**PROPOSED BASEMENT FINISH AND WALKOUT  
SIDE ENTRANCE AT  
22 MORTIMER CRECENT, AJAX, ONTARIO.**

**20 108713**

Reviewed for the  
accessory apartment only

Plans review subject to revision noted  
Reviewed by: KW  
Town of Ajax Date: Mar 15, 2021  
This review does not exempt the owner,  
designer, or the builder from complying with  
all pertinent regulations and by-laws of the  
Town of Ajax and the Ontario Building Code

**PROPOSED BASEMENT FLOOR PLAN**  
SCALE = 3/16" = 1'-0"

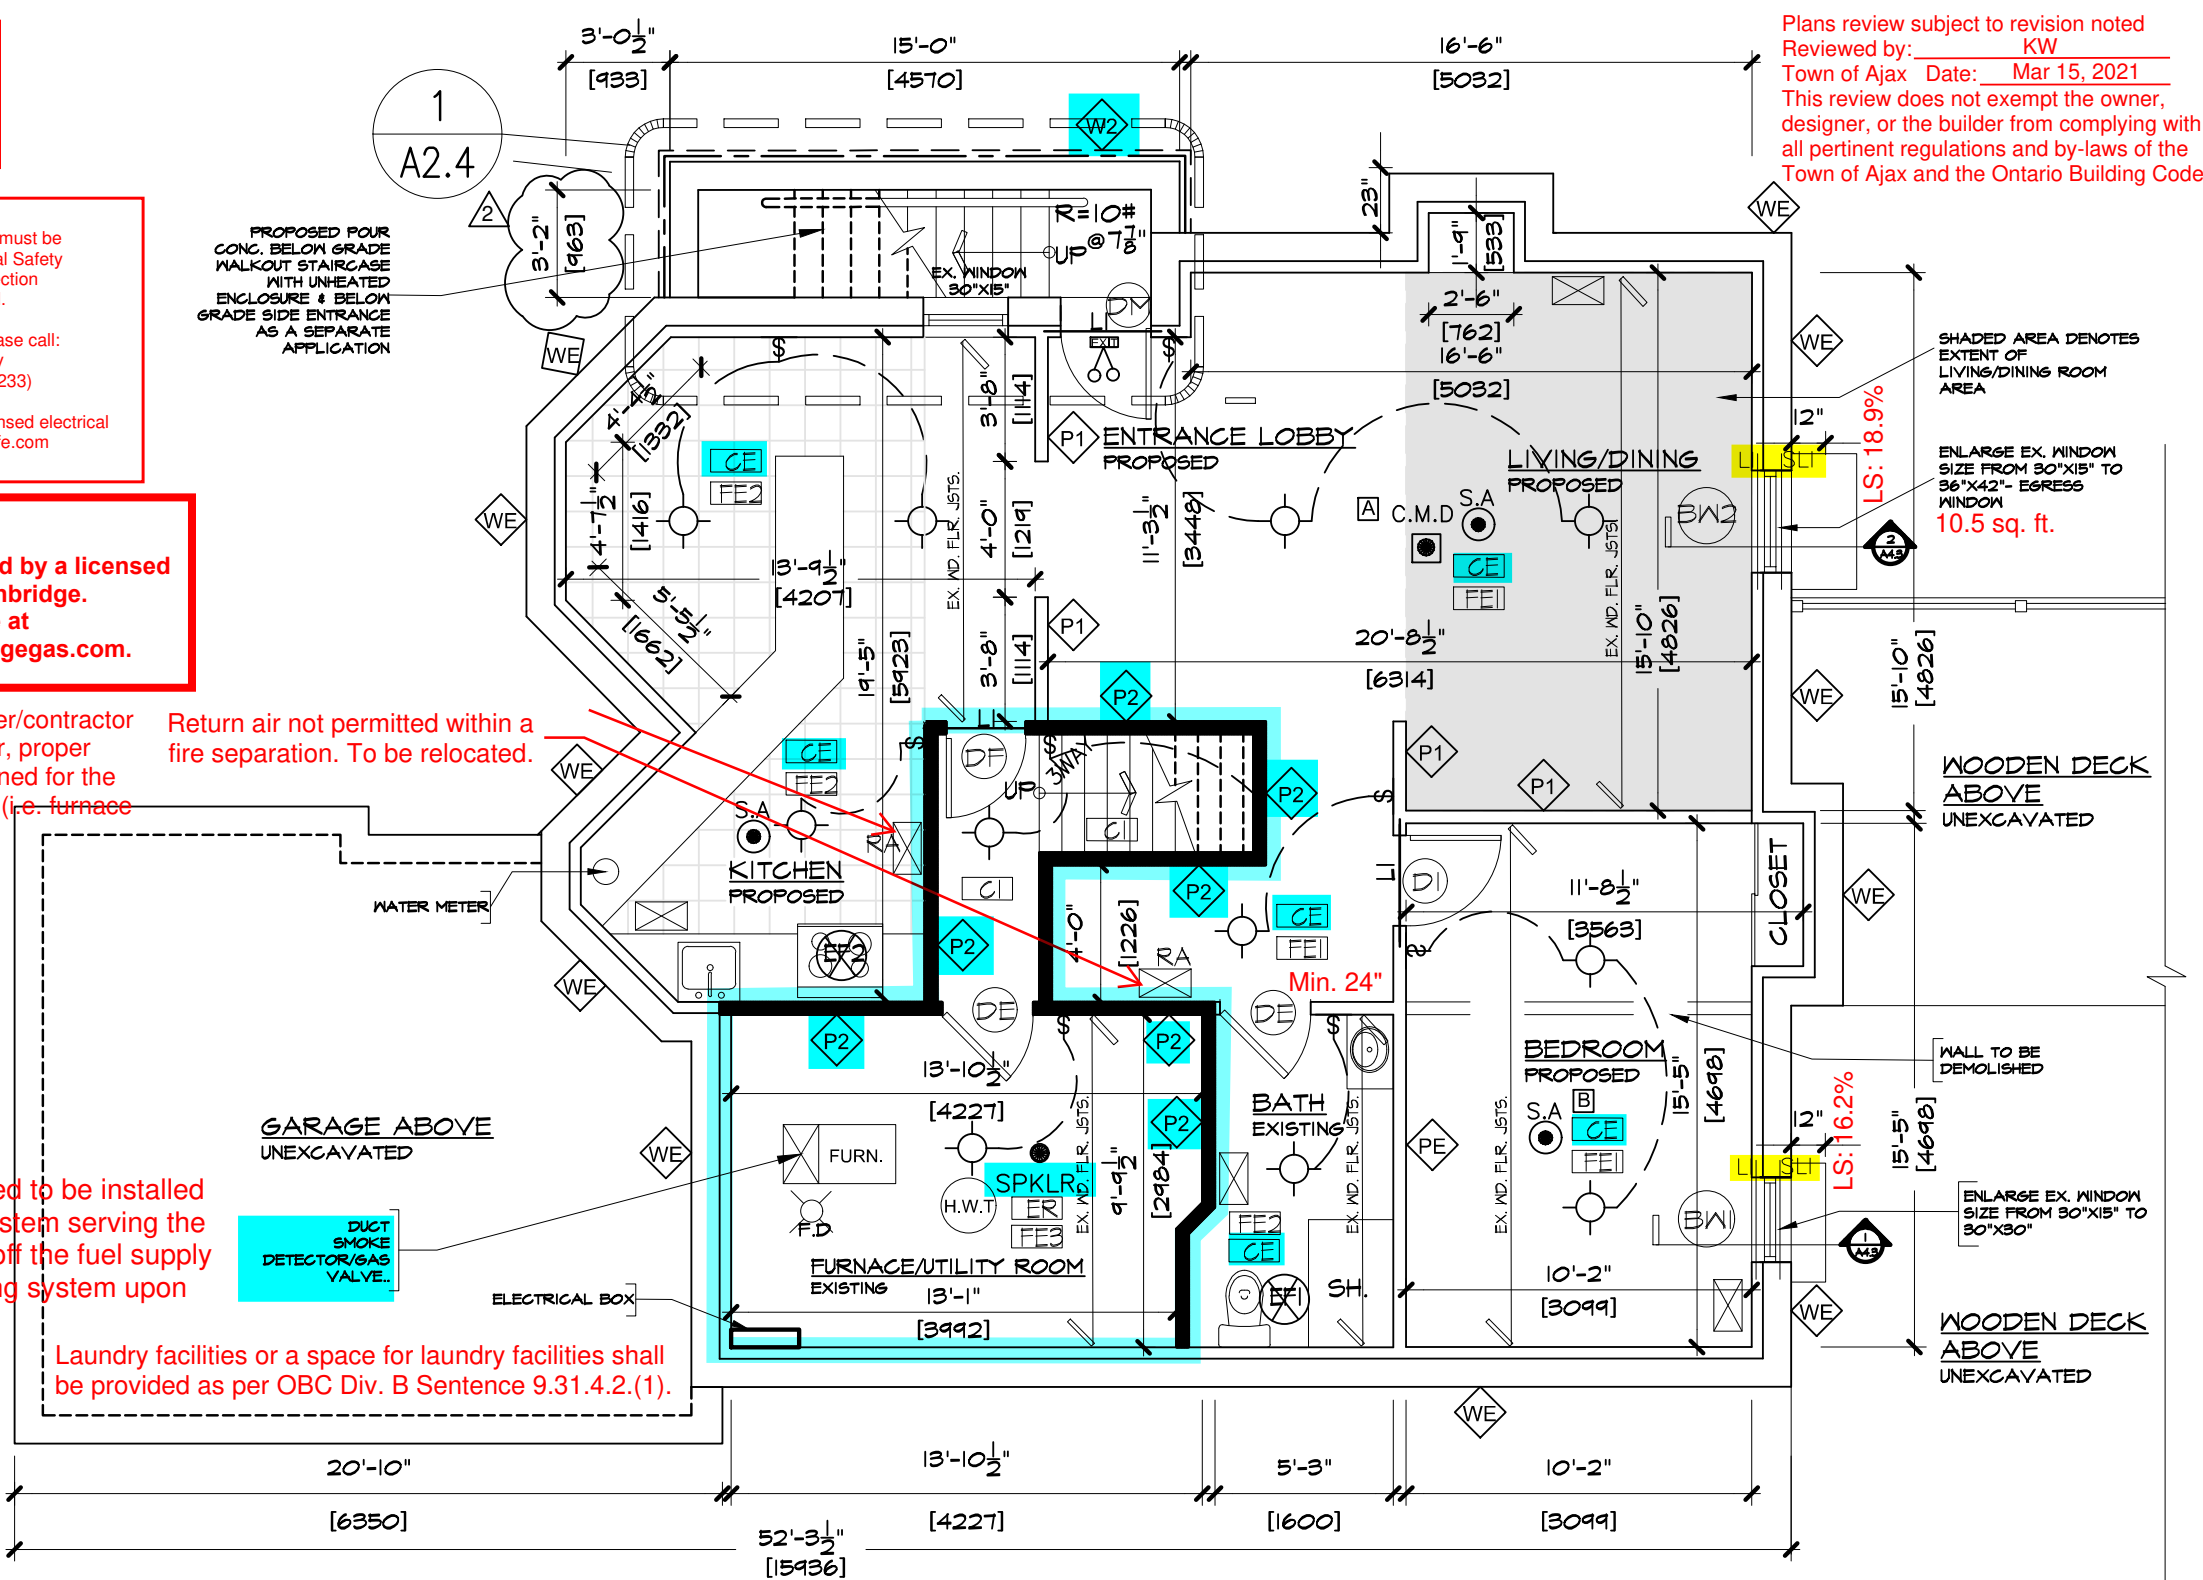
Return air not permitted within a fire separation. To be relocated.

Duct-type smoke detector required to be installed in the supply or return air duct system serving the entire building which would turn off the fuel supply and electrical power to the heating system upon activation.

Laundry facilities or a space for laundry facilities shall be provided as per OBC Div. B Sentence 9.31.4.2.(1).

All bathroom and kitchen areas require supplemental exhaust conforming to OBC, Div. B - Article 9.32.5.5.

Ventilation to conform to OBC, Div. B - Section 9.32.

All shower valves shall conform to OBC, Div. B - Article 7.6.5.2.

Waterproof finish required at all tub and shower areas to conform to OBC, Div. B - Subsection 9.29.2.

**OVERALL GROUND FLOOR PLAN**  
SCALE= 3/16"=1'-0" [1:64]

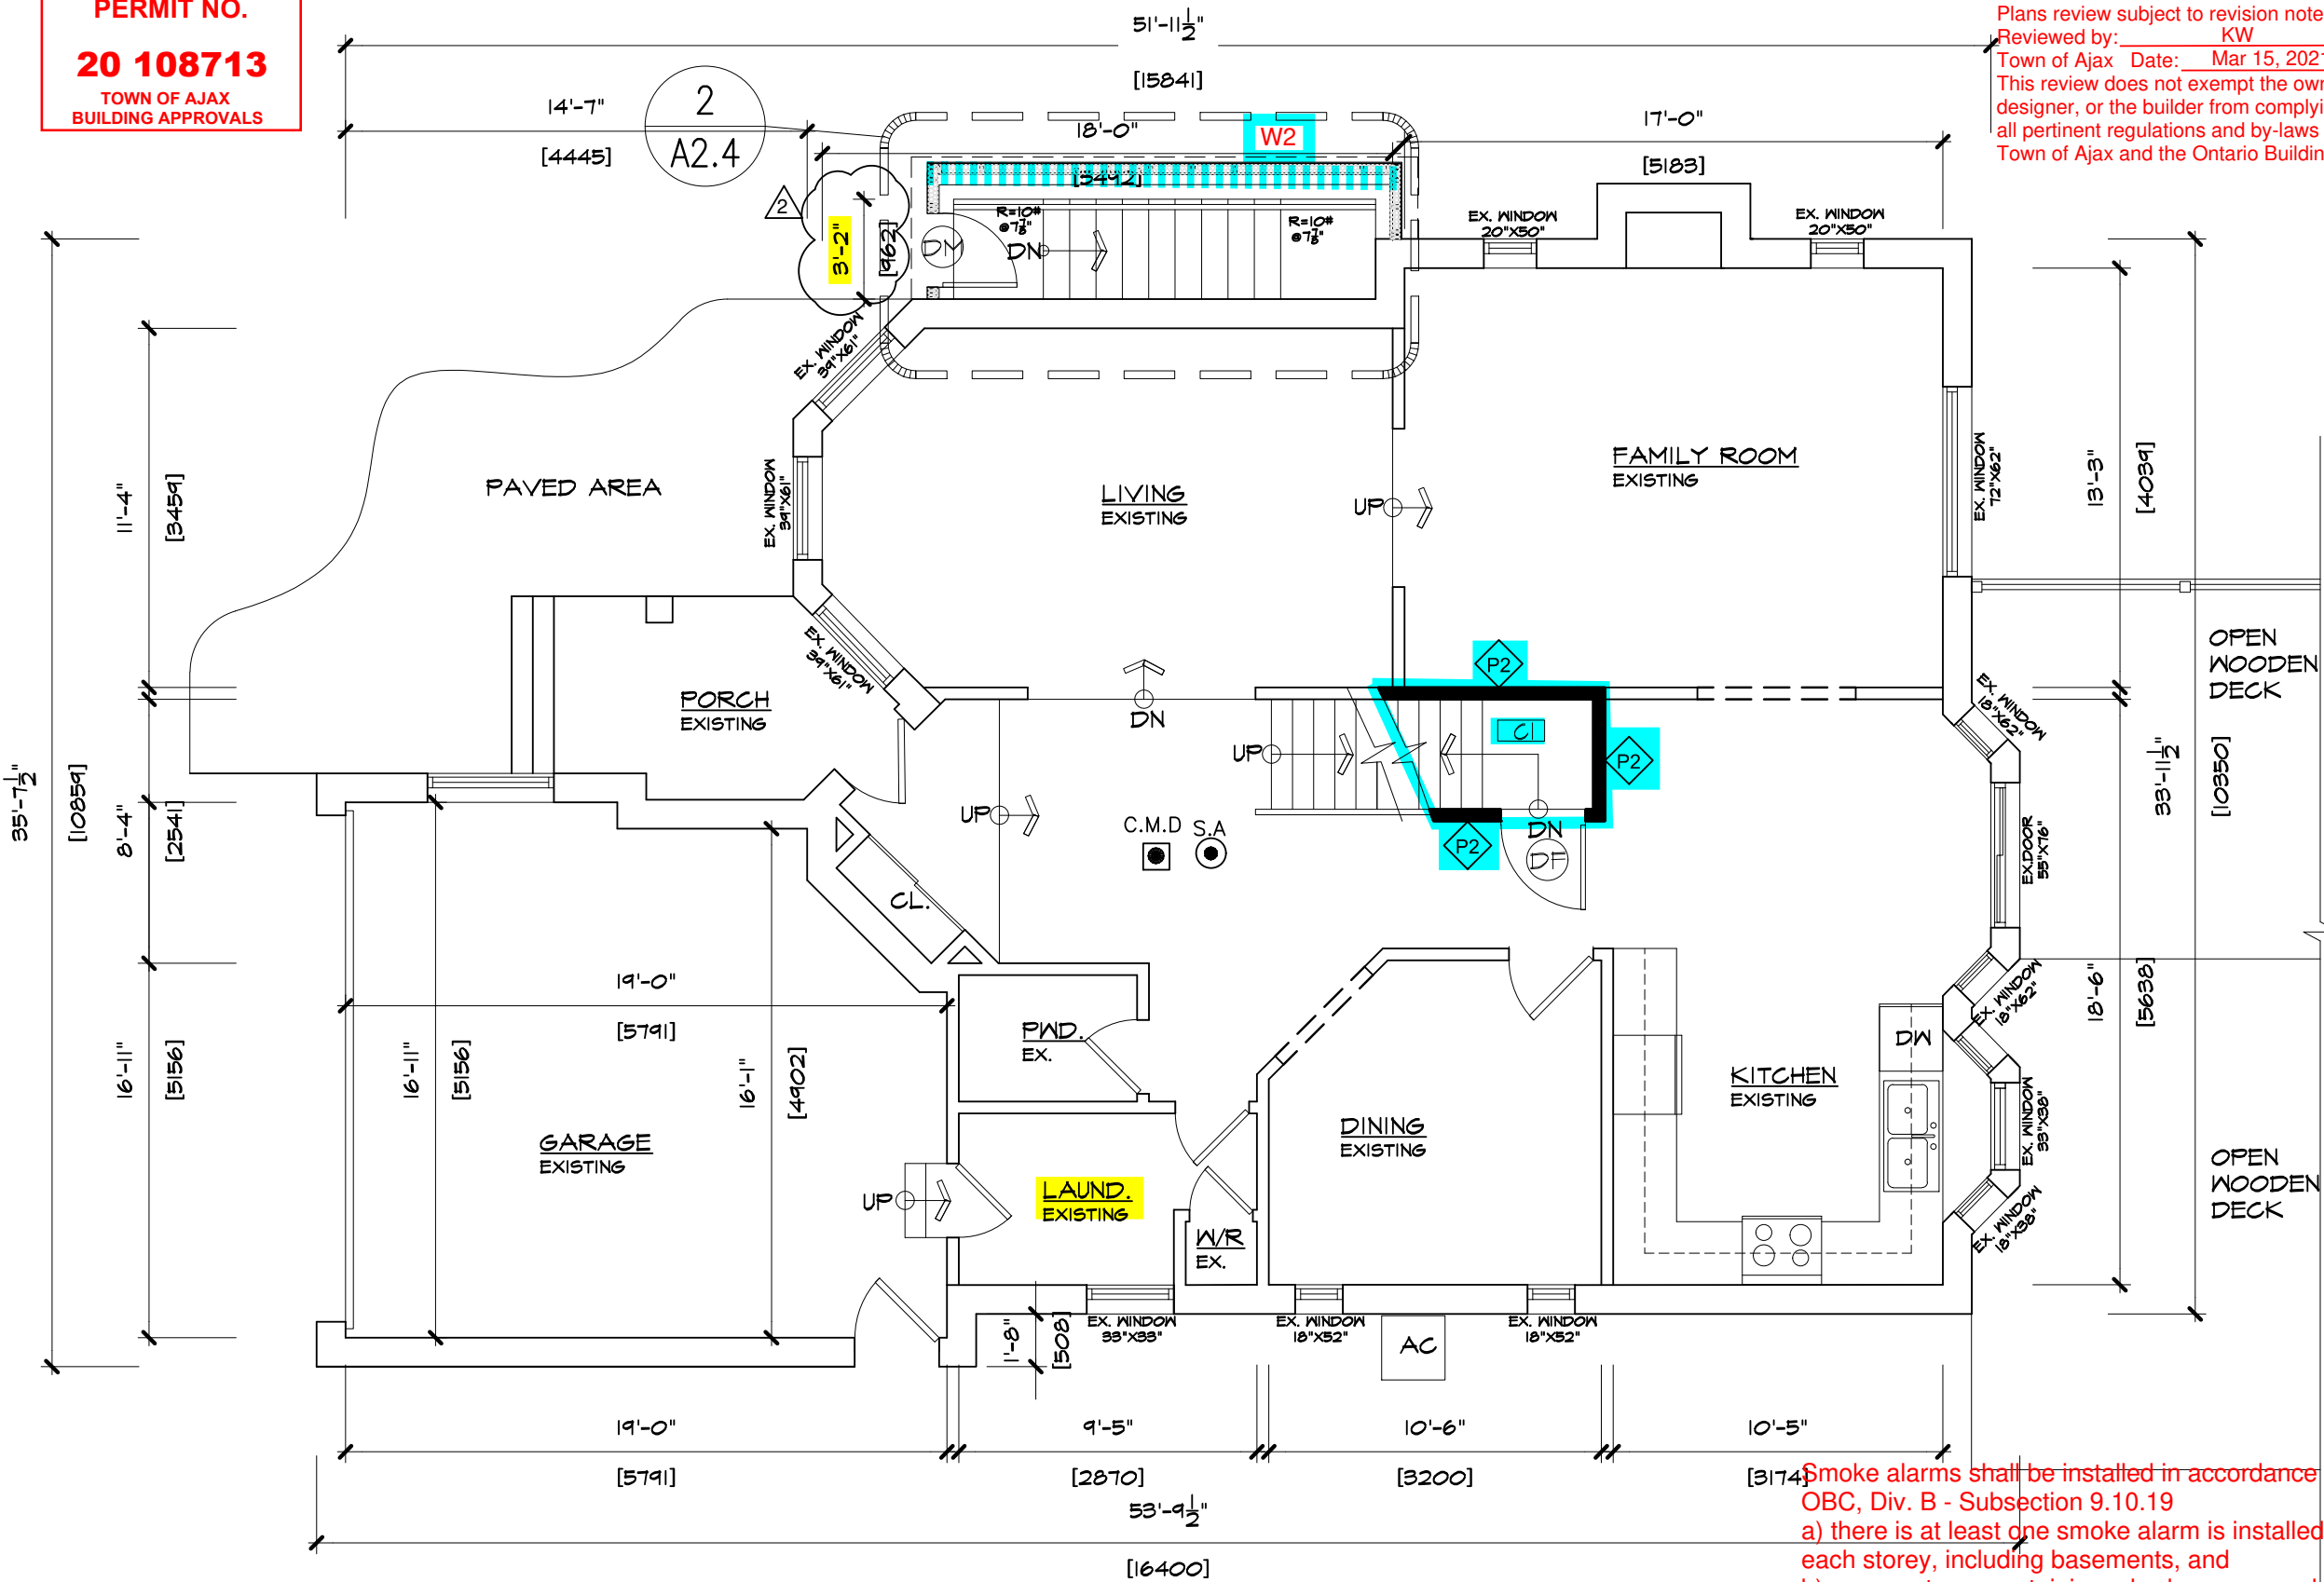
Carbon monoxide alarm required to be installed adjacent to each sleeping area in accordance with OBC, Div. B - 9.33.4.2.

Smoke alarms shall be installed in accordance with OBC, Div. B - Subsection 9.10.19  
a) there is at least one smoke alarm is installed on each storey, including basements, and  
b) on any storey containing a bedroom, a smoke alarm is installed, in each bedroom, and in a location between the bedrooms and the remainder of the storey, and if the bedrooms are served by a hallway, the smoke alarm shall be located in the hallway.

SECTION DETAIL AT  
1 BELOW GRADE EGRESS WINDOW  
A4.3 SCALE= 1/2" = 1'-0"

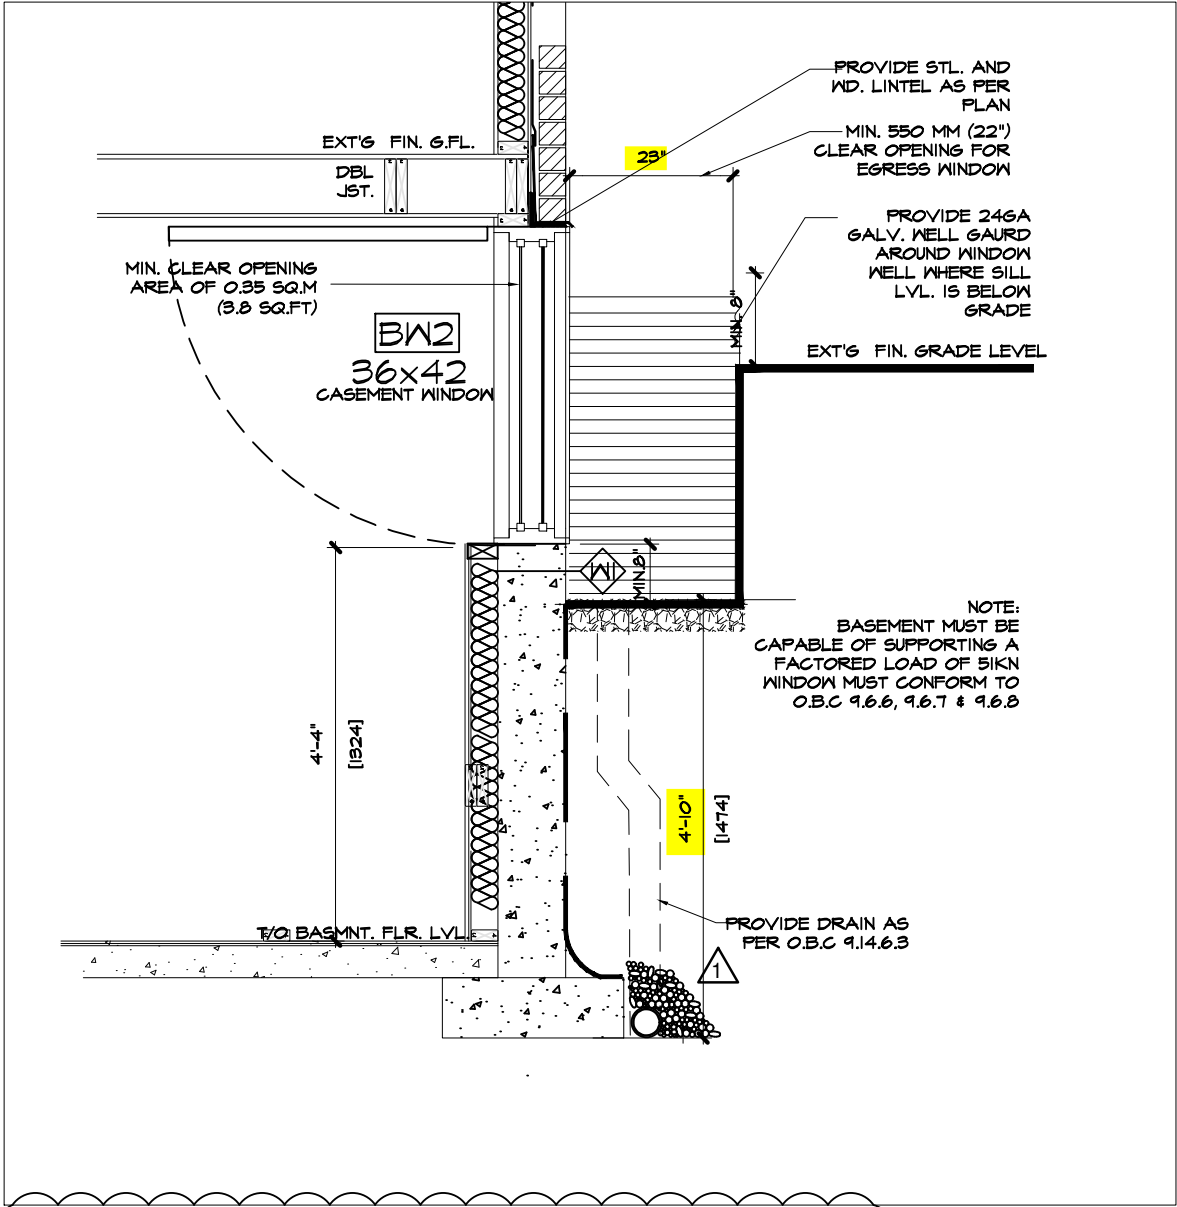
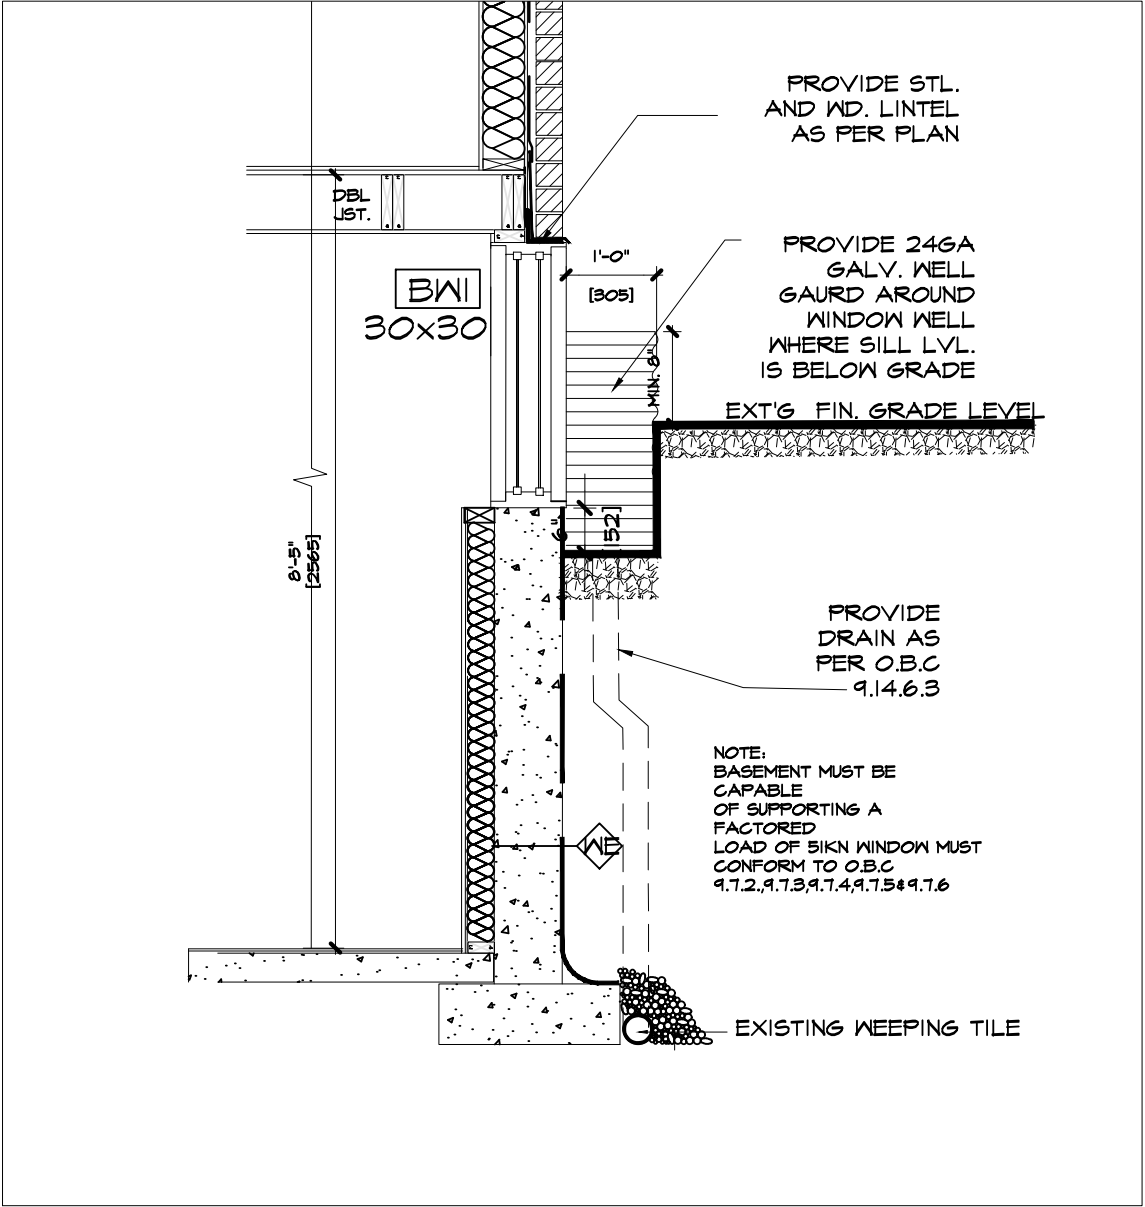
Wood framing members that are not pressure-treated with a wood preservative and that are supported on concrete in contact with the ground shall be separated from the concrete by not less than 0.05 mm polyethylene film or Type S roll roofing. OBC, Div. B - Article 9.23.2.3.
